HUTCHISON
SMITH
ARCHITECTS

RE: DSRFY 2020-14 The River at Parkway Apartments:

Attention: Chris Samples, Garden City Planning and Zoning

We are resubmitting our design for the River at Parkway Apartments with revisions based upon comments that we received from the Design Review Committee at the public hearing on May 18, 2020. Please find attached the following revised documents:

DESIGN REVIEW LANDSCAPE PLAN

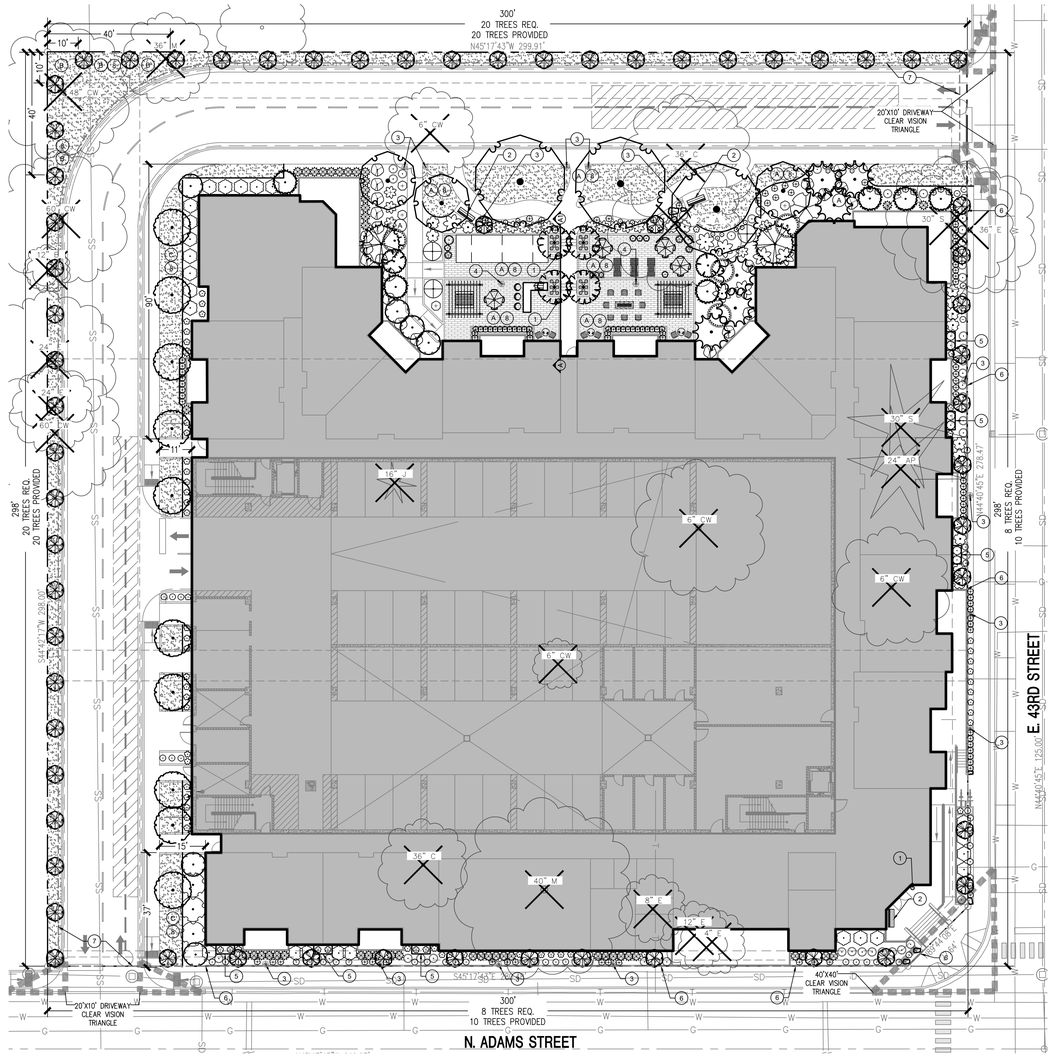
Landscaping Tree Compliance

Each frontage along Adams and E. 43rd Streets is 300 feet. The required minimum number of trees for each frontage is one Class II or III tree and six Class I trees (one class I tree per each 50 feet). The zoning ordinance allows substitution of two Class I trees for one Class II or III tree. Due to the limited planter width we are requesting approval of this substitution, making the total number of required trees to be eight Class I trees along each frontage. We are providing ten Class I trees along Adams Street and ten along E. 43rd Street to comply with this requirement.

A SOUTH ELEVATION - ADAMS STREET

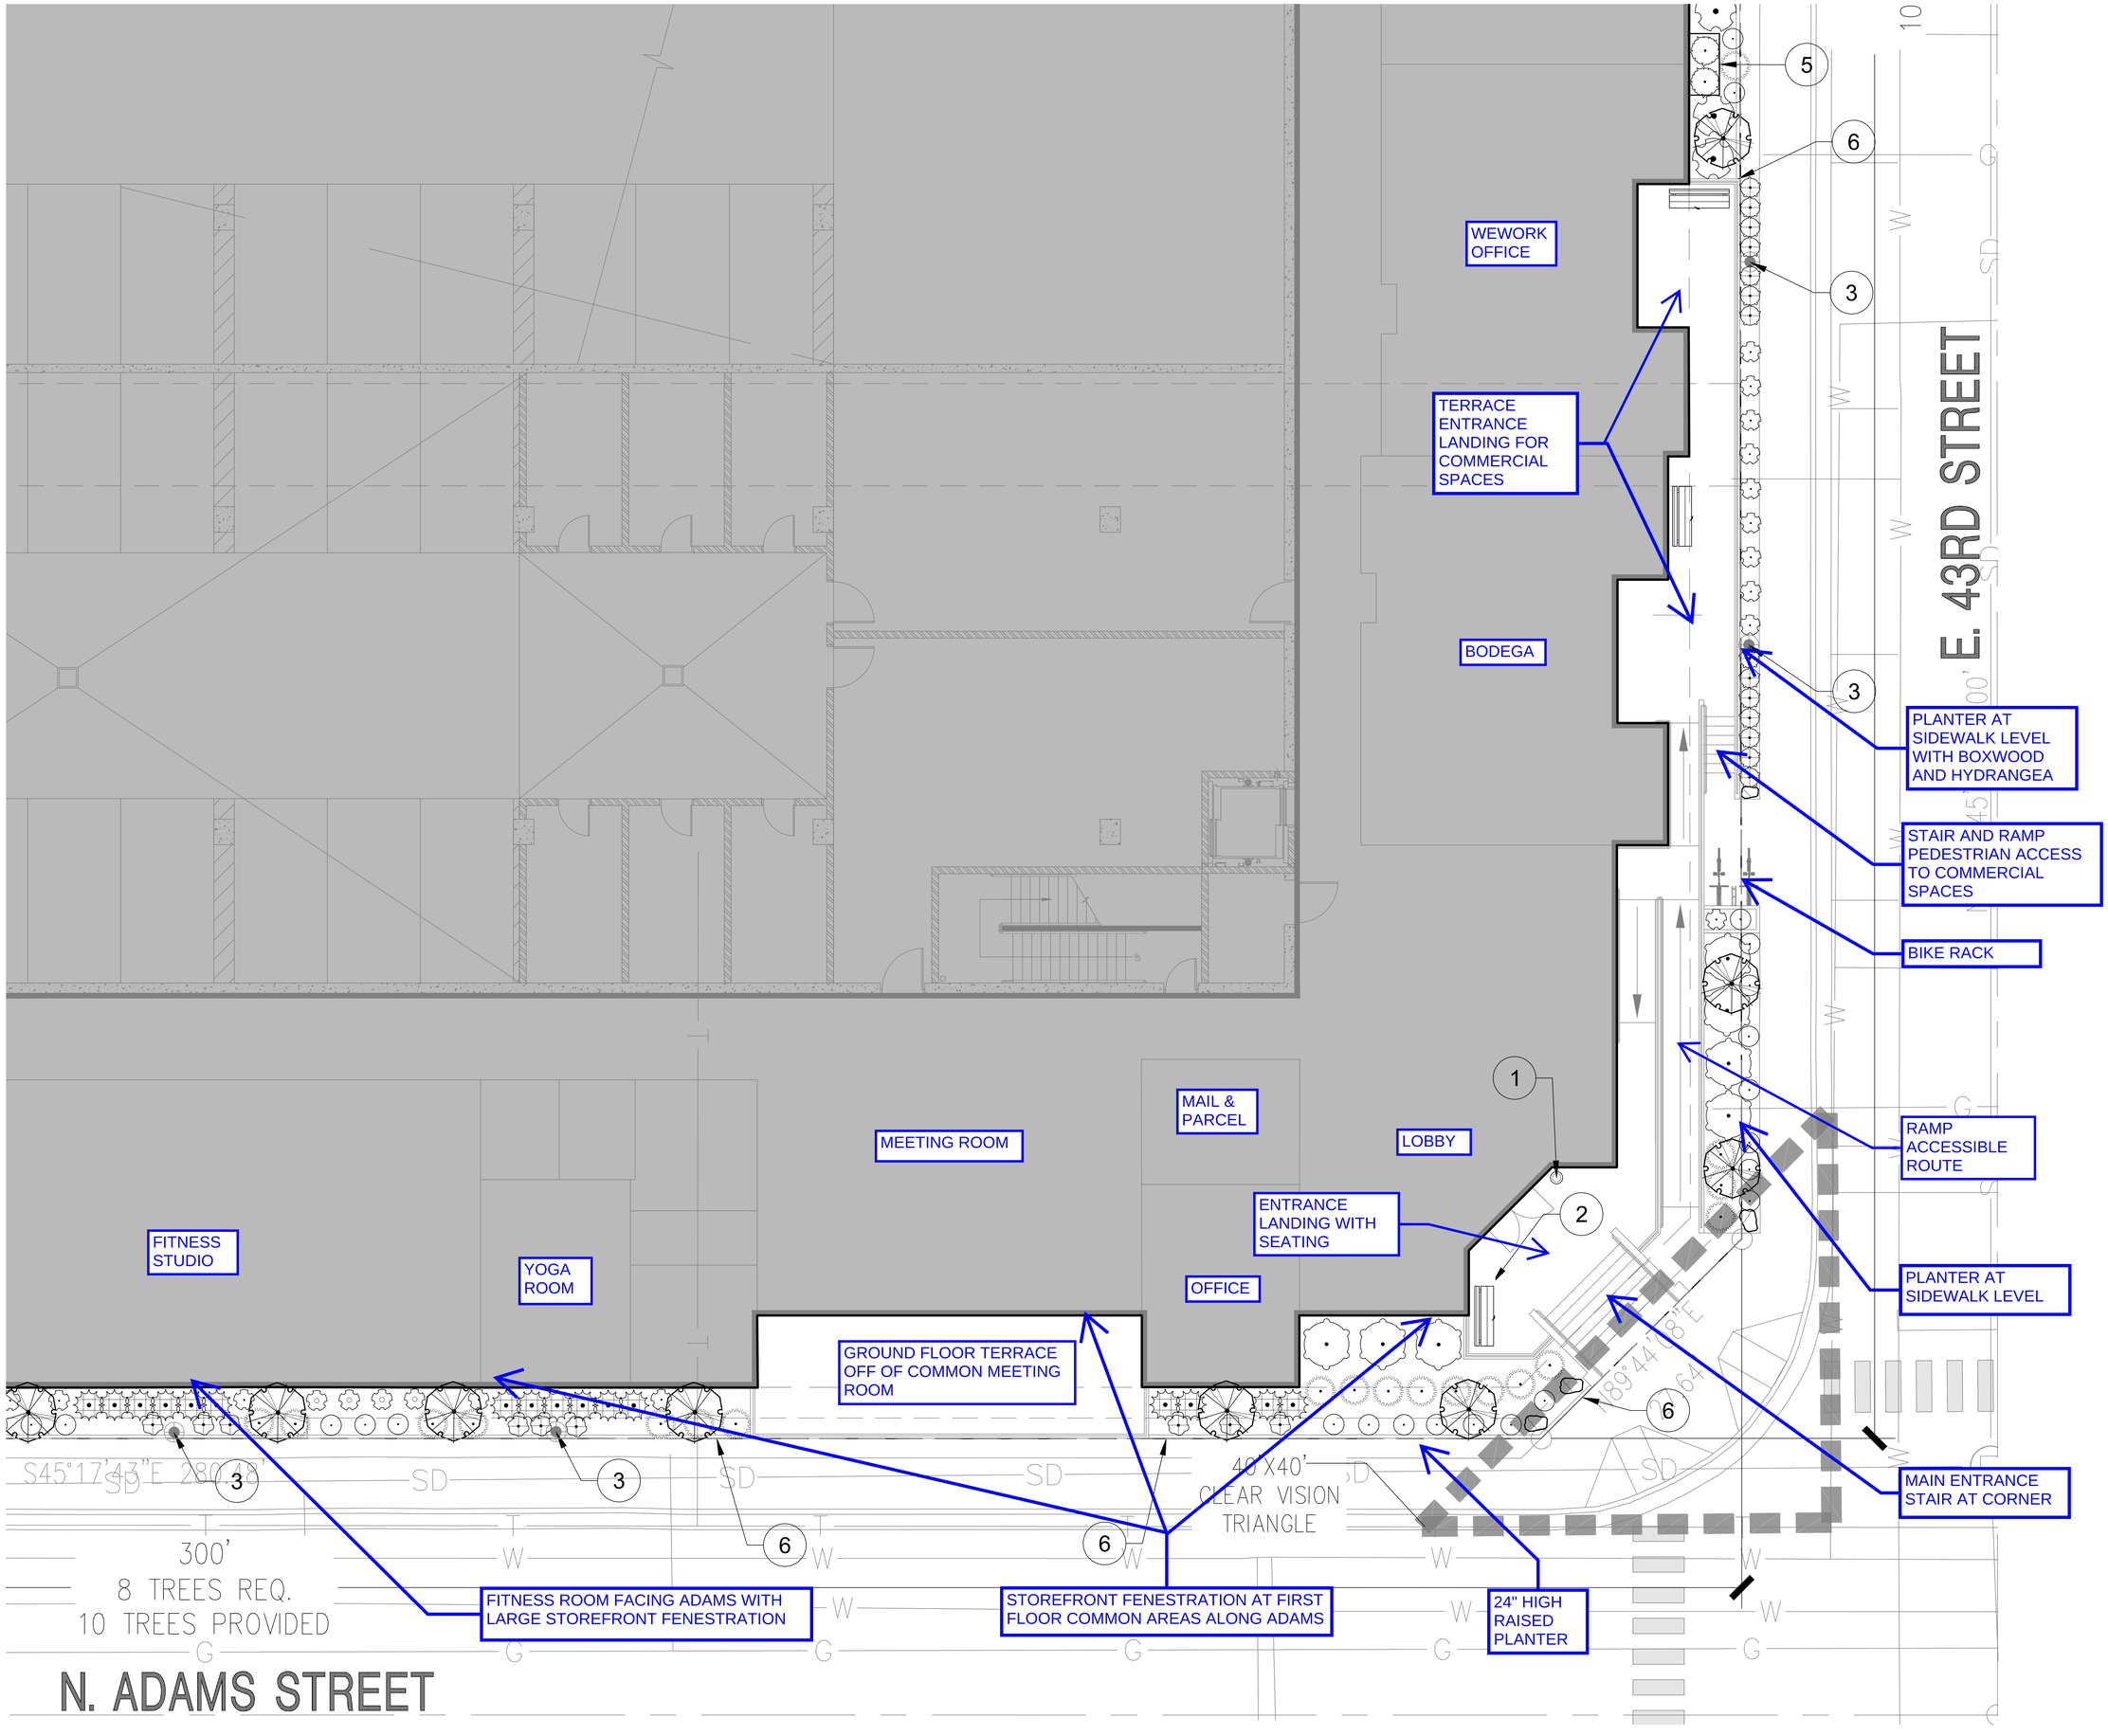
Commercial Area landscaping, bike and pedestrian access

Adams Street Elevation

The ramp providing access to the main apartment entrance and the commercial entrances has been redesigned so that bicycle parking is now provided near the stairs and ramp and a wider landscaping planter is provided along the side of the ramp. There is also a two-foot-wide landscape planter between the commercial entrance terrace and the sidewalk where ornamental grasses are proposed. Please see the enlarged plan depicting this area in more detail. We believe this has improved the pedestrian and bicycle connection to the commercial spaces and improved the overall street scape.

Before we introduced the mixed-use commercial spaces into the building it was our intent to provide a design for the ground floor elevation along Adams with a more commercial feel. We believe we have accomplished this by through a number of means including the prominent main stair at the corner with a large entry terrace with seating, commercial style aluminum storefront fenestration for the ground floor common areas facing Adams, a large raised terrace off the common area meeting room and floor to ceiling windows in the fitness room facing Adams. The low planter we are providing all along the sidewalk provides a pedestrian friendly scale to the street scape.

We also looked at the location of the commercial spaces and we still firmly believe that the proposed location near the corner on 43rd Street is where they need to be. The proposed store will be very visible from Adams Street. The improvements to the ramp, bike parking and landscaping make the access much improved. Having all the common areas along Adams designed in a commercial style will actually provide a greater commercial look and feel along more of the Adams frontage.

D WEST ELEVATION

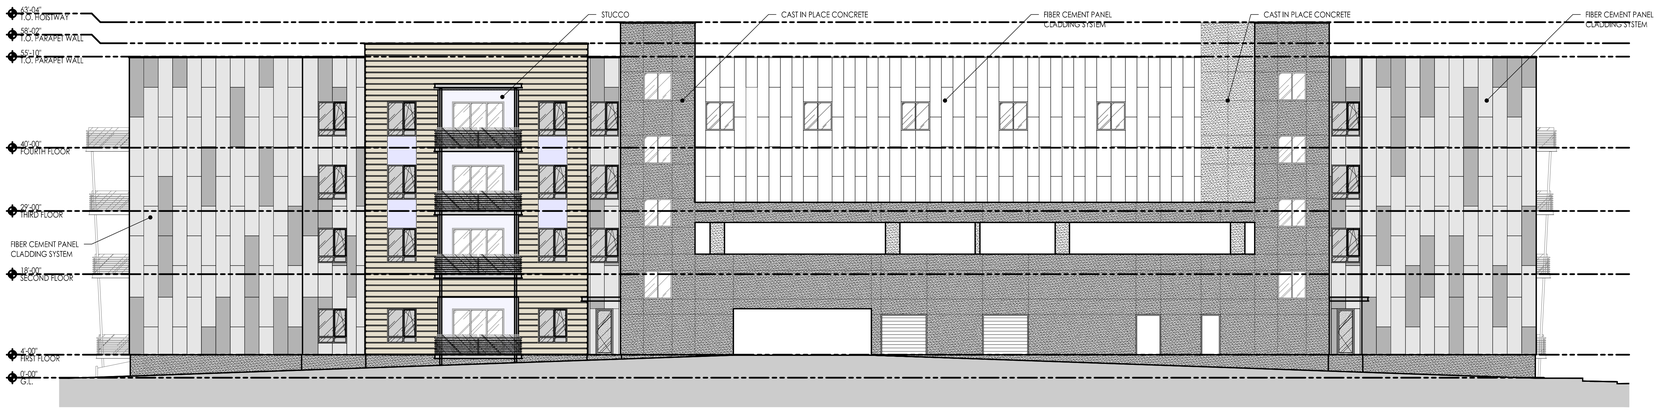
West Elevation

We appreciate the comments by the Committee regarding the west elevation. We have taken this opportunity to re-examine how the west elevation and the inner walls above the parking structure fit in with the overall design of the building. We have added windows to the corridor walls above the parking structure as suggested. We have also added windows to the west wall of both stairs to provide more variation to the façade. We have re assessed the vertical metal panels that were previously proposed, and we are now proposing to use fiber cement panels that have a similar appearance and will be painted to provide the same alternating color pattern. We are also proposing to use these panels on the inner walls above the parking structure as well. We have eliminated the metal panels on the parking structure itself and we are proposing to leave those walls as concrete with the architectural joint pattern shown on the new elevation. There was also a concern regarding whether cars in the parking structure would be visible from the neighboring property. We have included a section which illustrates the relationship of the parking structure to the adjacent property line. The solid low wall guardrails of the garage will effectively block the view of the vehicles. As was also discussed in the hearing the setback of the building, the fence at the property line and the landscaping will all work together to minimize the impact on the neighbors to the west.
